# Access Compliance Report

## Public Rights-of-Way

| Intersection ID: 23352                  | Main Street: LANCER_DR | Cross Street: LONDONTOWNE_DR            | Location: NE           |
| ADA ID: 4F28A1670DD1                    | Ramp Type: PerpDiag    | Initial Pass/Fail: Fail                 | Overall Compliance: No |

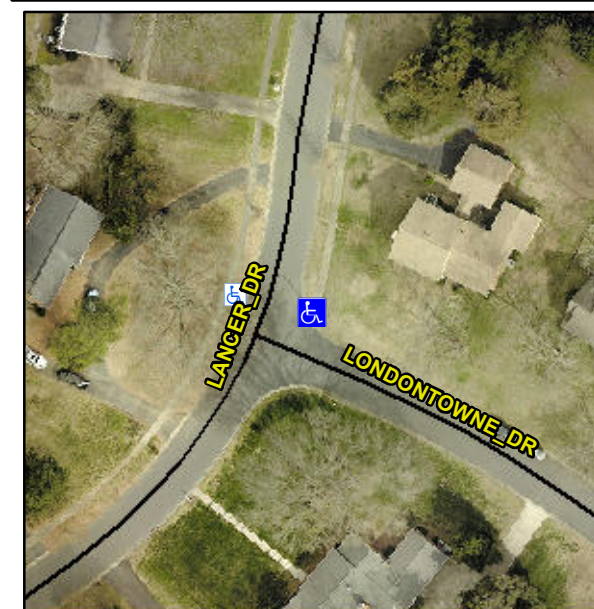
**Not Found, R304.5.1**

| Compliance | Description           | Data  | Compliance | Description                 | Data  |
|------------|-----------------------|-------|------------|-----------------------------|-------|
| No         | Ramp Width (in)       | 40.5  | Yes        | Ramp XSlope (%)             | 0.4   |

**Remove & Replace Curb Ramp With Two New Directional Ramps or Equivalent.**
